TO: Mills City Council
FROM: Megan Nelms, AICP, City Planner
DATE: February 25, 2025
SUBJECT: Final Plat – Lots 2A & 3A, Sage Addition

Case Number: 25.01 FSP

A MINOR BOUNDARY ADJUSTMENT PLAT OF LOTS 2 & 3
SAGE ADDITION

Lots 2A & 3A, Sage Addition – Boundary Line Adjustment Final Plat

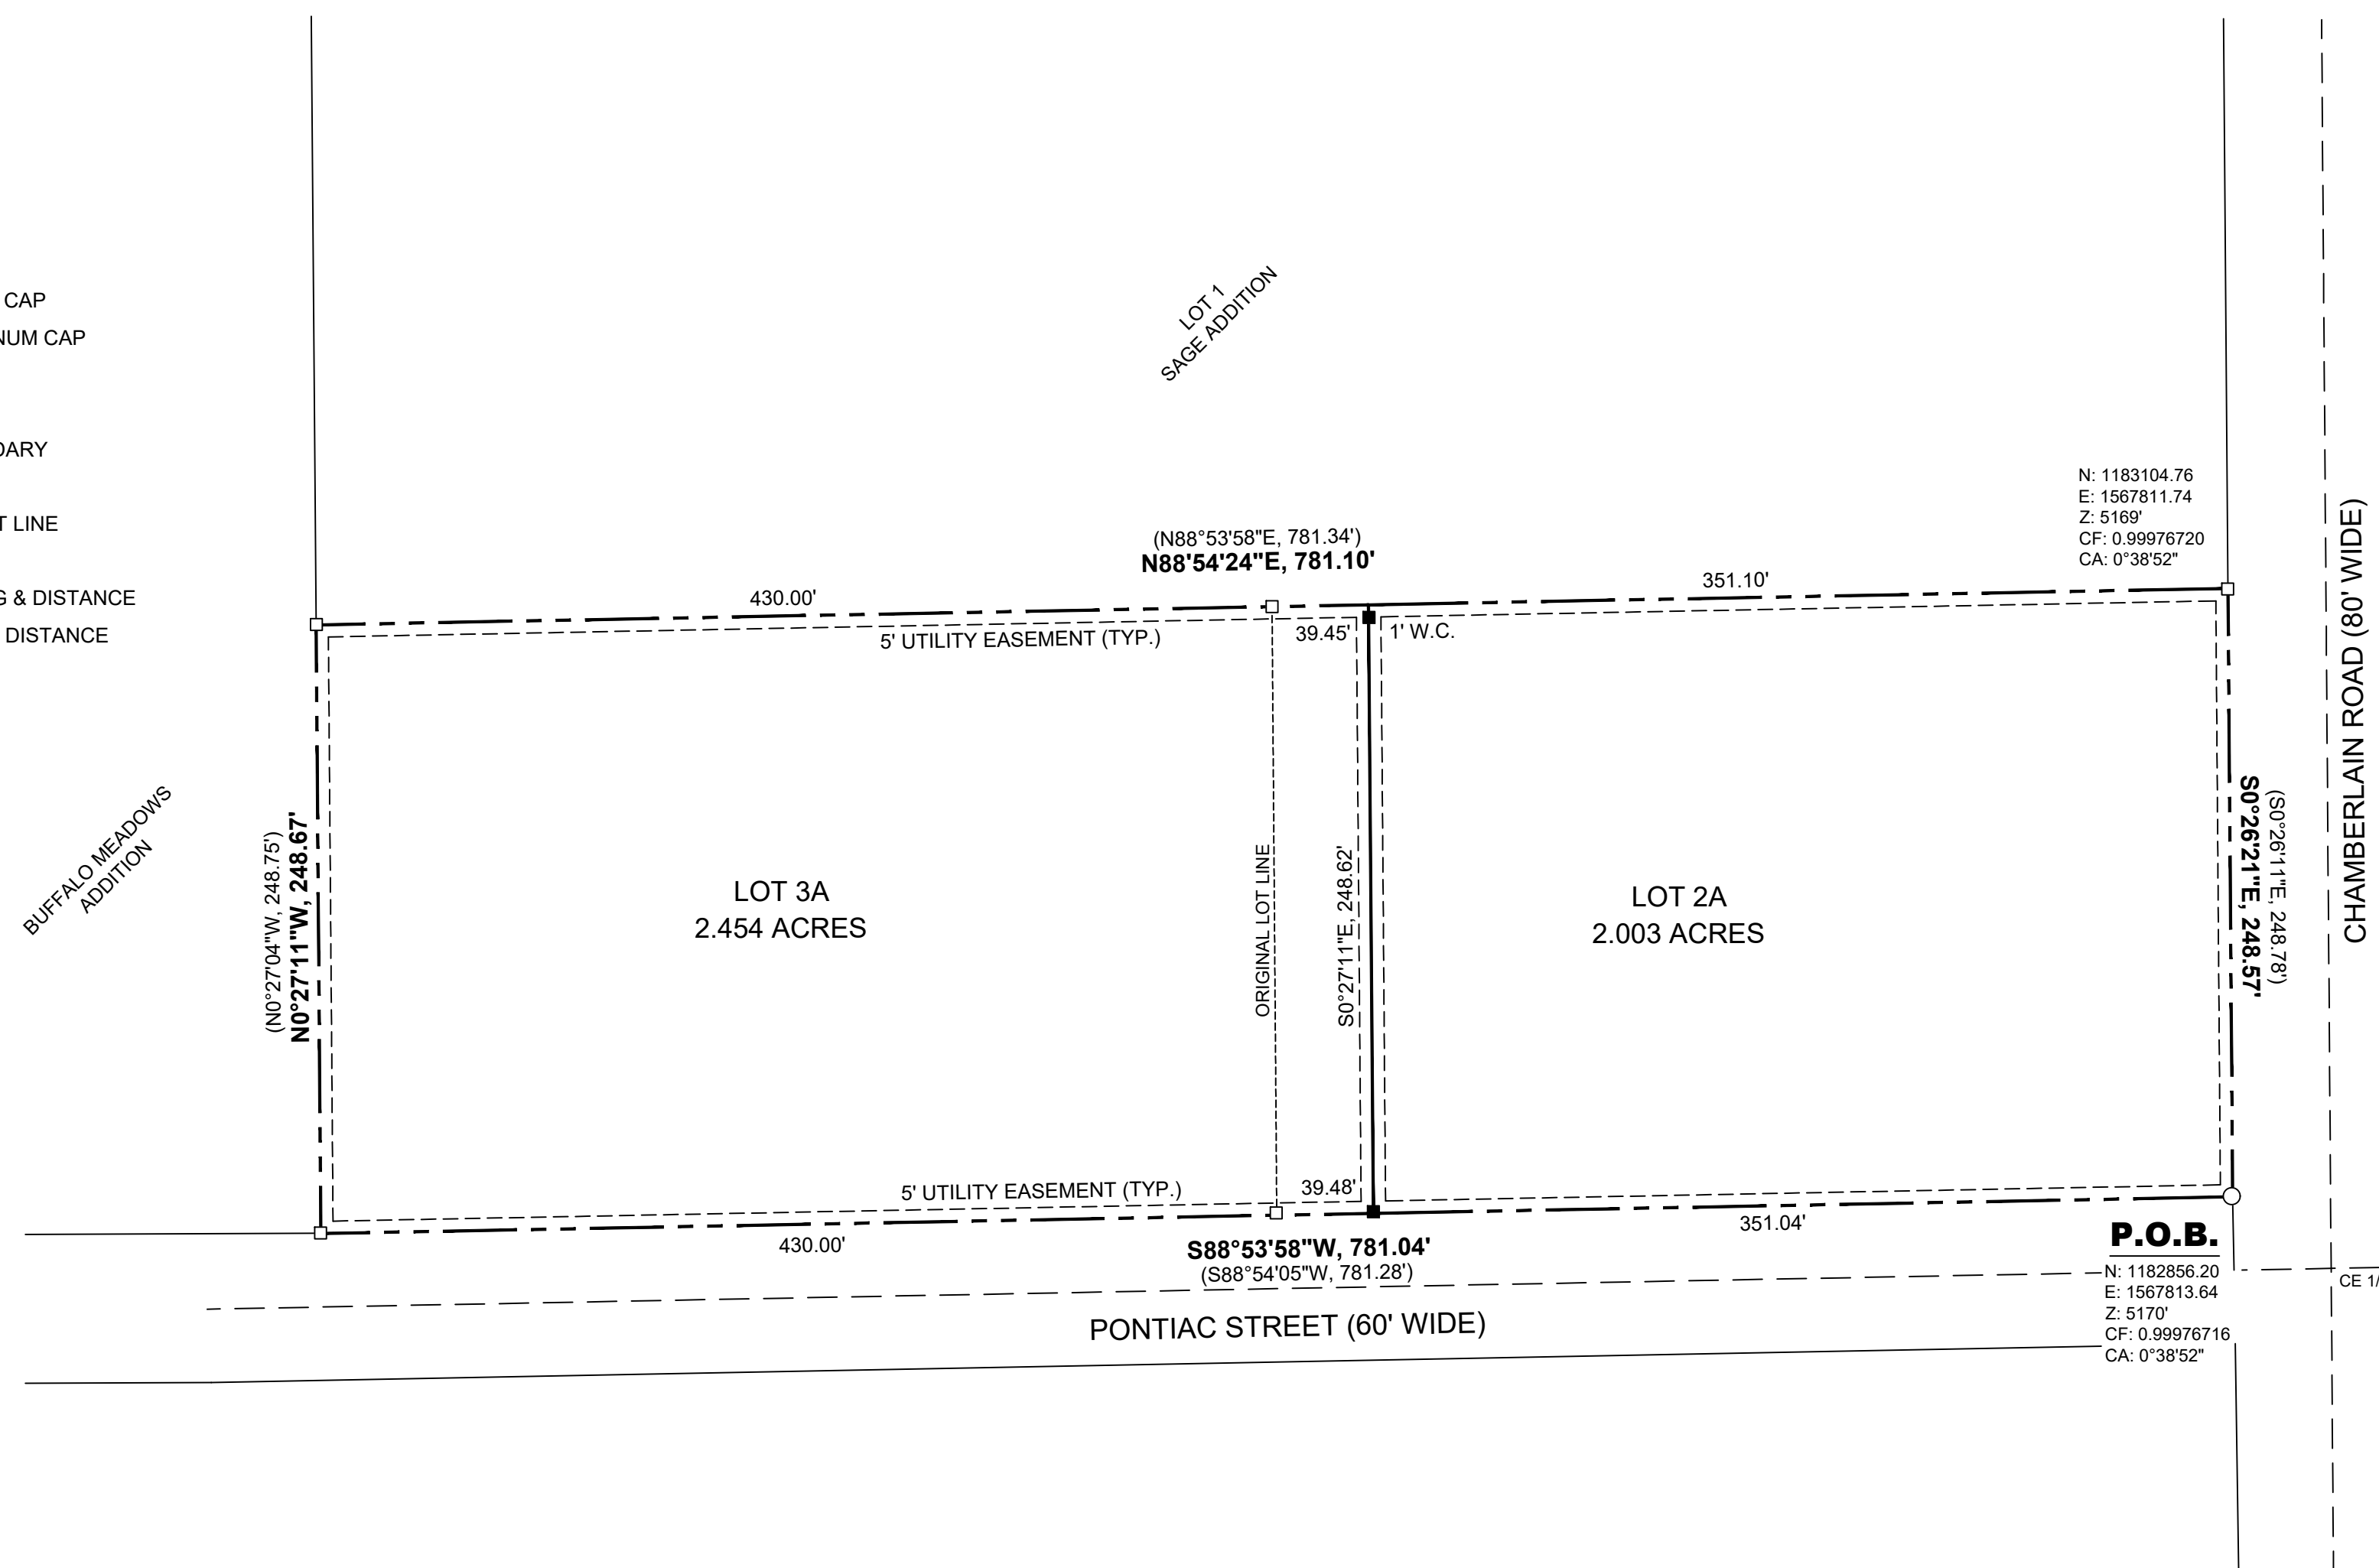
1. Submit a signed City of Mills Subdivision Plat application
2. Add a 5' general utility easement around the boundary of each lot
3. Label the lot line being vacated by the plat.
4. Buffalo Meadows Addition is adjacent on the western boundary of the subdivision, not Lot 4, Sage Addition. Re-label and update the calls in the legal description in the Certificate of Dedication.

5. The Dedication shows the acreage of the subdivision is 47.65-acres. Correct to 4.457-acres.

6. **Survey Reviews:**
 - a. Verify the plat scale is 1" = 60' not 1" = 100'
 - b. Verify all line types in the legend match those on the plat face
 - c. Revise the plat in the vicinity map and Surveyors Certificate to match the Dedication.
-

1. Add a 5' general utility easement around the boundary of each lot
2. Label the line shown on Lot 3A
3. Survey Reviews:
 - Verify the plat scale is 1" = 60' not 1" = 100'
 - Verify all line types in the legend match those on the plat face
 - Revise the plat in the vicinity map and Surveyors Certificate to match the Dedication.

commission know that the line being discussed is the original lot line. He can add the line to the legend or remove it all together. Member Bryson asked him to just label the line. Megan stated she will revise the considerations to remove or label the line being vacated.
